Access Compliance Report Public Rights-of-Way (Curb Ramps)

Main Street: FOSTER_RD Cross Street: KEMPTON_DR Location: SW

ADA ID: RPRK211221124550 Ramp Type: Type 1 - Perpendicular Diagonal Initial Pass/Fail: Fail Overall Compliance: No Severity Score: 15

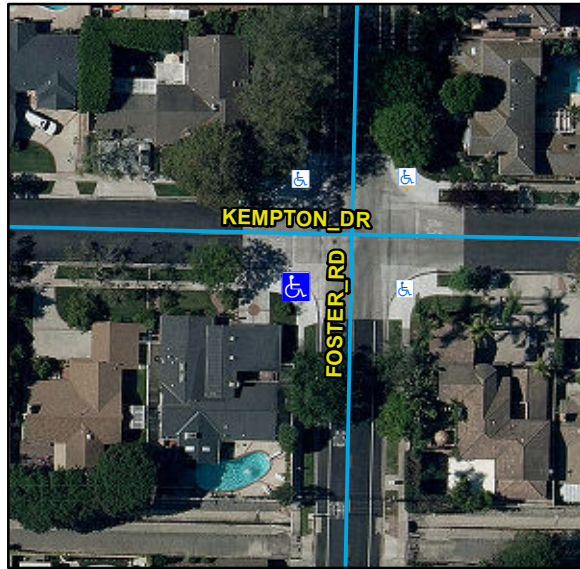
Compliance	Description	Data	Compliance	Description	Data
N/A	Ramp Length (in)	77	N/A	Flare Type LT	
Yes	Ramp Width (in)	48			N/A
No	Ramp Run Slope (%)	8.4	N/A	Flare Slope LT (%)	N/A
Yes	Ramp Cross Slope (%)	1	N/A	Flare Traversable LT	N/A
N/A	Landing Present	N/A	N/A	Flare Type RT	
N/A	Landing Length (in)	N/A			N/A
N/A	Landing Width (in)	N/A	N/A	Flare Slope RT (%)	N/A
N/A	Landing Run Slope (%)	N/A	N/A	Flare Traversable RT	N/A
N/A	Landing Cross Slope (%)	N/A	N/A	DWS Provided	N/A
N/A	Landing Movement Obstructed?	N/A	N/A	DWS Contrast	N/A
	Landing Movement Type	N/A	N/A	DWS Length (in)	N/A
N/A	Landing Shared	N/A	N/A	DWS Full Width	N/A
N/A	Clear Space	Yes	N/A	DWS Offset Left (in)	N/A
N/A	Clear Space To Crosswalk (in)	N/A	N/A	DWS Offset Right (in)	N/A
N/A	Marked Crosswalk 1	No	N/A	Marked Crosswalk 2	No
	Crossing 1 Direction	E		Crossing 2 Direction	N
	Marked Crosswalk 1 Width (in)	N/A		Marked Crosswalk 2 Width (in)	N/A

N/A	Ramp Inside Crosswalk 1	N/A	Yes	Ramp Inside Crosswalk 2	N/A
	Crossing 1 Slope (%)	5.5		Crossing 2 Slope (%)	1
	Crossing 1 Cross Slope (%)	0.1		Crossing 2 Cross Slope (%)	0
N/A	Gutter Ponding	N/A	No	Curb Slope	5.9
Yes	Gutter Lip Height (in)	0		Road Run Slope (%)	1.2
N/A	Gutter Run Slope (%)	N/A		Road Cross Slope (%)	0.4
N/A	Gutter Cross Slope (%)	N/A			
Yes	Overall Surface Condition: Acceptable		Yes	Perp Joint Present	Yes
	Cross Gutter Present?	Yes		Spandrel Present?	Yes
	Replace Cross Gutter?	No		Replace Spandrel?	No

Remove & Replace Curb Ramp With Two New Directional Ramps or Equivalent.

R304.2.2, STD 1115
